ENVIRONMENTAL REVIEW TEAM REPORT

ELDERLY HOUSING PROPOSAL WOODBURY, CONNECTICUT

JUNE 1981

FIGURE 2.
CONCEPTUAL SITE PLAN*

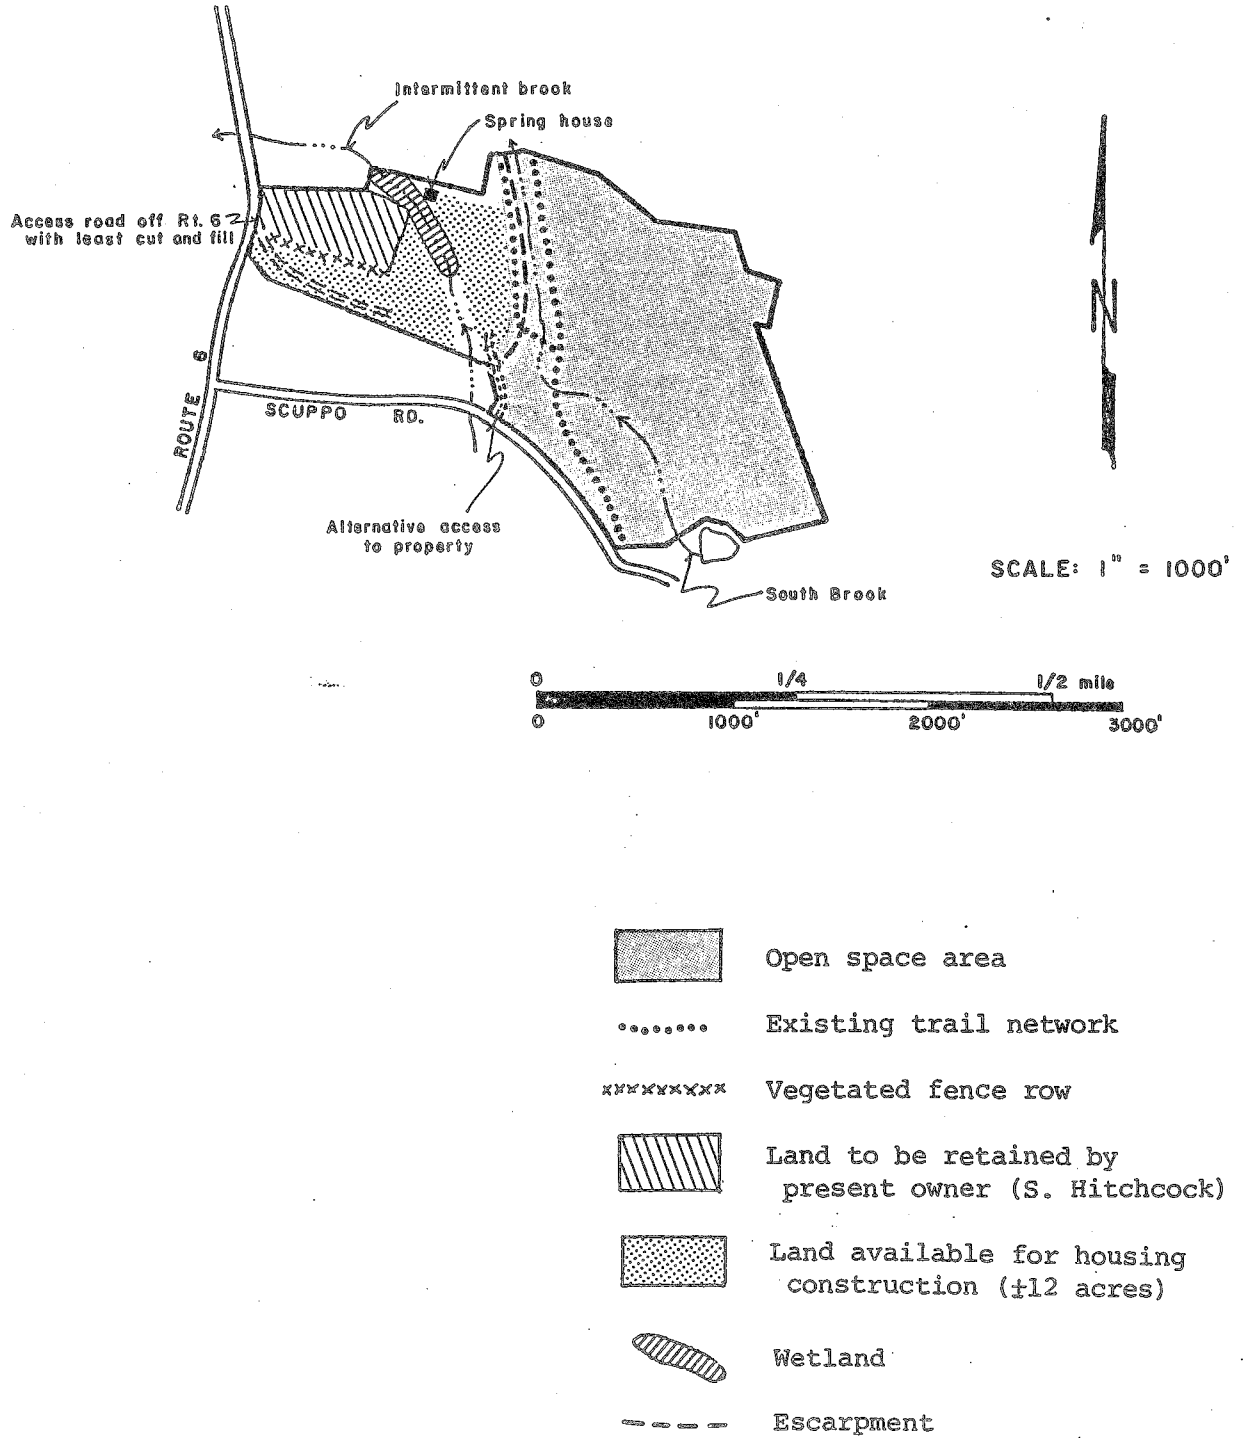
6. Other Comments
 - 1) If access off of Rt. 6 is created for this site, consideration should be given to locating the entrance road as shown in Figure 2 to keep cuts, fills and grades to a minimum.

- 2) The location and depth of the lead pipeline running through the tract from the spring house (see Figure 2) should be determined as it will influence earth cuts and final grades.

- 3) The natural drainageway and narrow strip of wetland along the drainage-way (see Figure 2) will need consideration in final site design.

As shown in Figure 2, there is an existing trail network along South Brook. This trail offers a pleasant hiking experience but was observed to be severely eroded in places, particularly in the vicinity of the stream crossings. If this trail network is to receive continued use, efforts should be made to create a stable treadway, and correct existing critical erosion areas.

FIGURE 5.
VEGETATION TYPE MAP

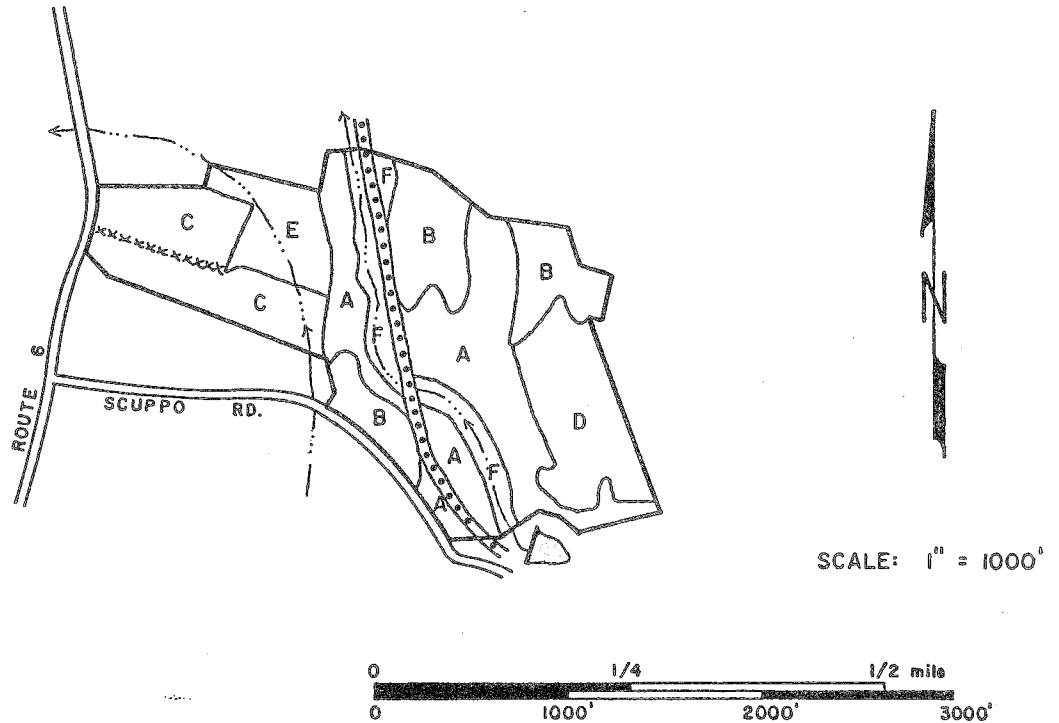
From a vegetation standpoint, development of the elderly housing complex as proposed in the open fields (vegetation type C) off Route 6 would have the least negative impact.

It would be desirable to retain the trees which are present along the fence rows which divide these fields. These trees add considerable character to this portion of the property and therefore consideration should be given to incorporation of these trees and the fence rows into the final site plans for this proposal. If any or all of these trees are retained, special care should

If the magnitude of development demands expansion to the old field area to the north and east (vegetation type E), provisions should be made to salvage the trees which were recently planted. These trees could be used for landscaping purposes on the developed portions of the tract. Even if the old field area is not to be developed, trees could still be transplanted and utilized for landscaping. Ideally, transplantation of these trees should take place during the early spring when these trees are still somewhat dormant in terms of growth.

The trees which are present in the northern hardwood stand (vegetation type B) and also the softwoods/hardwoods stand (vegetation type D) are crowded and would benefit by receiving a fuelwood thinning. A fuelwood thinning which removes approximately one third of the trees in the overstory would reduce competition between residual trees for space, sunlight, water and nutrients. Over time the residual trees would respond by more vigorous growth. The remaining trees would also become healthier and more resistant to degradation by environmental factors such as insects, diseases and adverse weather conditions. Only the poorest quality trees should be removed during this thinning. These should include trees which are severely damaged, trees with very small crowns, trees with large seams, trees which are directly competing with healthy high vigor trees and undesirable species such as red maple and cankered black birch. This thinning would produce between four and six cords of fuelwood per acre. Revenues received from these thinnings could be utilized for improvement of the abandoned trolley track and establishment of a trail system for recreation and fire control. Once again, access roads should be carefully laid out so they may be used as the backbone for a recreational trail system.

FIGURE 6.
 RECHARGE AREA MAP OF POMPERAUG RIVER
 AQUIFER IN SITE VICINITY

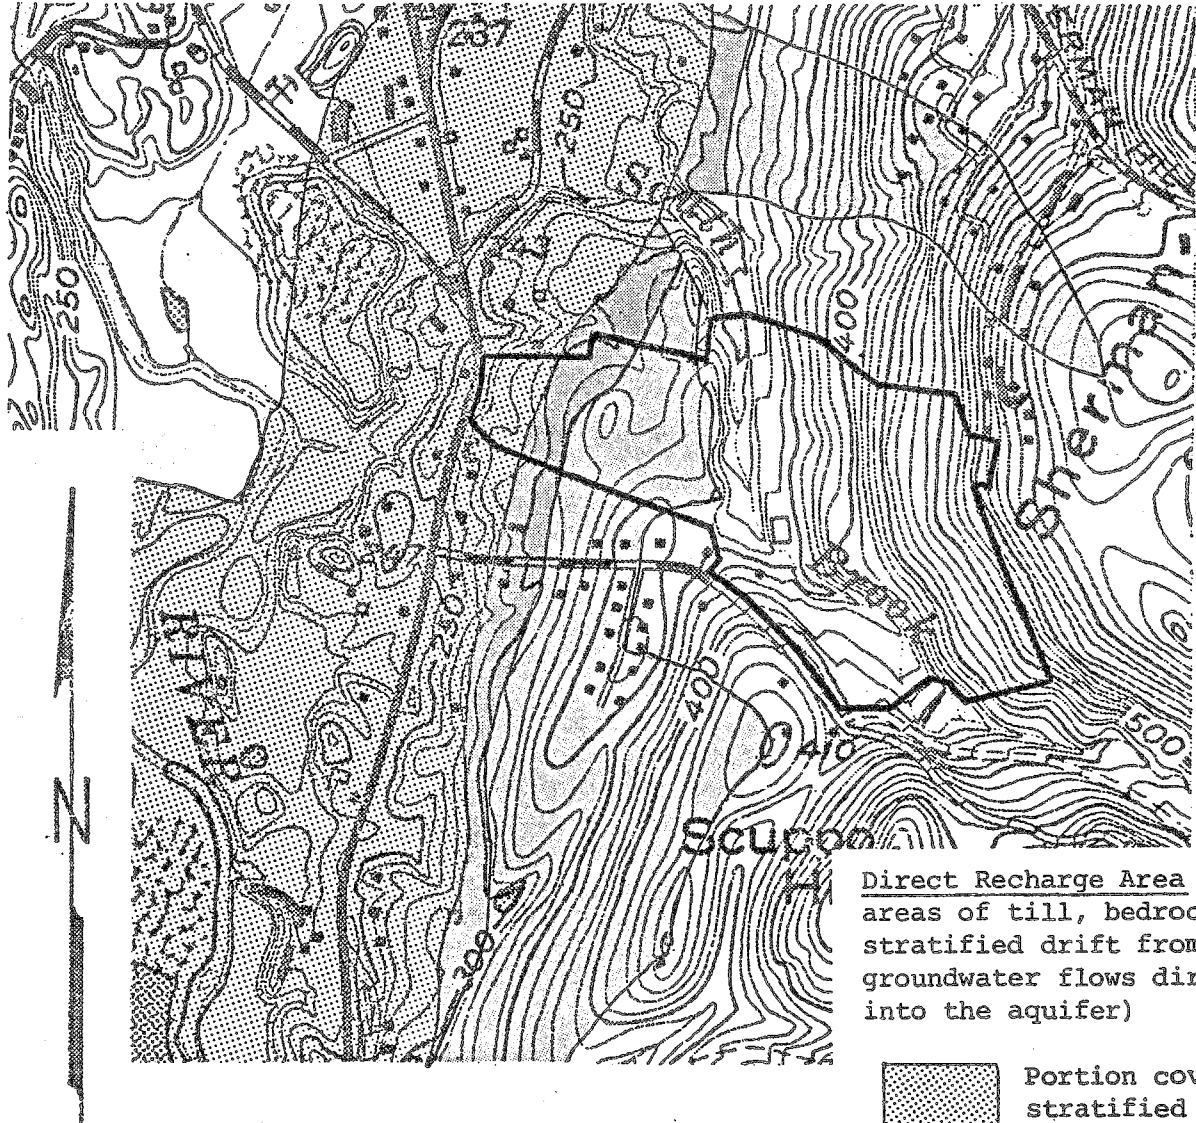
One reason for suggesting that this may be necessary is the location of the site in relation to the Pomperaug River aquifer. As shown in Figure 6, the location of the site is on the direct (primary) recharge area. This area, through direct infiltration, supplies the recharge for what eventually becomes the Middle Quarter well field. Calculations regarding effluent discharge loadings of the aquifer as they relate to the distance to the wells should clarify the capacity of this site for on-site sewage disposal.
